## **ADDENDUM NO. 3**

**DATE:** April 15, 2019  
**FROM:** City of Grand Junction Purchasing Division  
**TO:** All Offerors  
**RE:** Riverside Park Improvements and Bike Path IFB-4621-19-DH

RIVERSIDE PARK TRAIL  
UTILITY DETAILS DETAILS

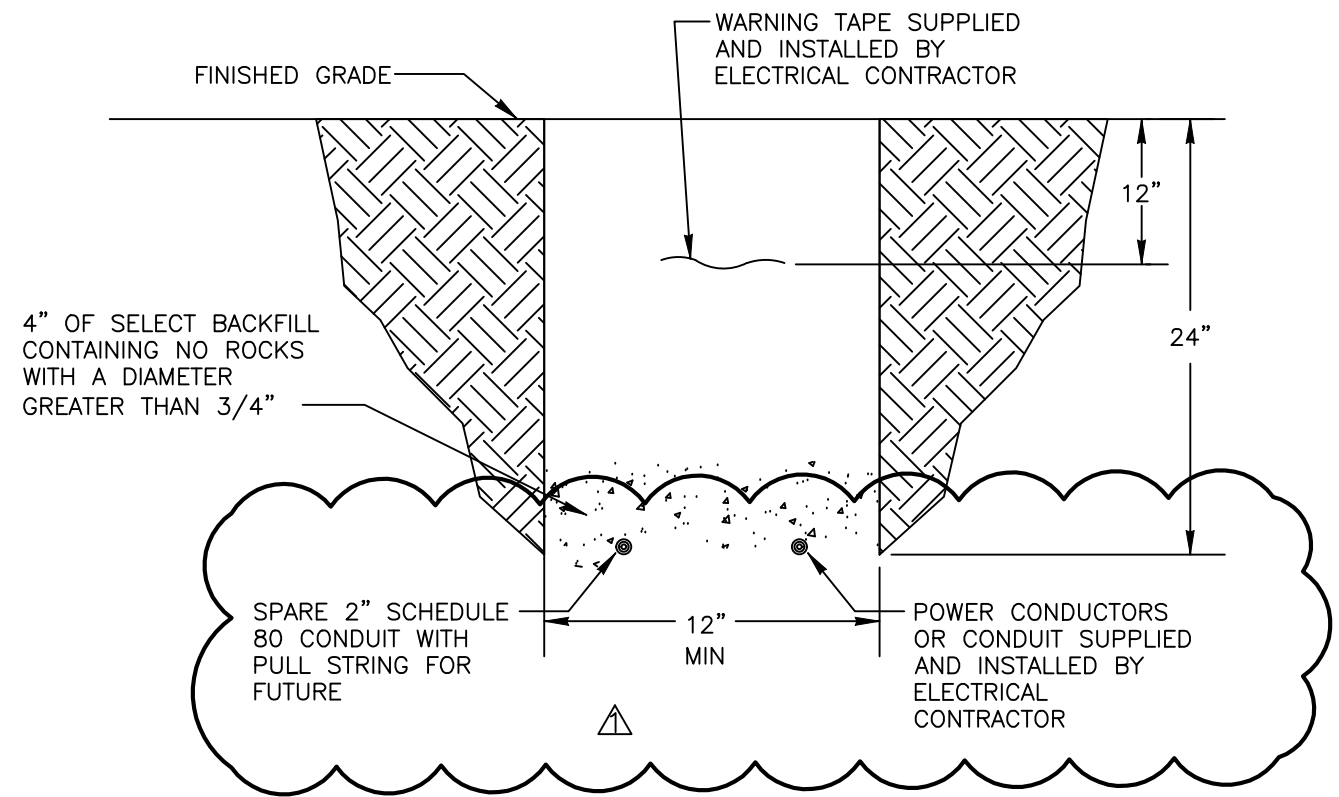
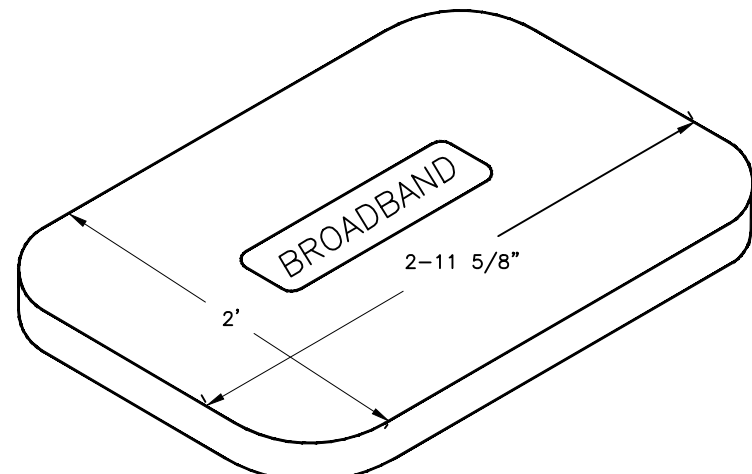
REVISION	DESCRIPTION	DATE	DRAWN BY	DATE
REVISION $\Delta$	CLARIFIED WIRE SIZE AND TRENCH	4-15-19	AJM	4-9-2019
REVISION $\Delta$			AJM	4-9-2019
REVISION $\Delta$			AJM	4-9-2019
REVISION $\Delta$			BH	4-9-2019

1. TRENCH WIDTH WILL BE 12".
2. STEEL GAS PIPE OR STEEL DUCT IS NOT ALLOWED IN TRENCH CONSTRUCTION.
3. WHERE UNDERGROUND UTILITIES CROSS OR ENCROACH INTO CITY STREETS THEY SHALL BE INSTALLED TO A DEPTH PROVIDING 3' MINIMUM COVER BELOW FINISHED GRADE.
4. PROVIDE 2-#6 THWN + #8GND IN 2" PVC SCHEDULE 80 CONDUIT BETWEEN PULL BOXES UNLESS SHOWN OTHERWISE, TYPICAL.
5. PROVIDE PULL STRING AND CAPS FOR SPARE CONDUITS.
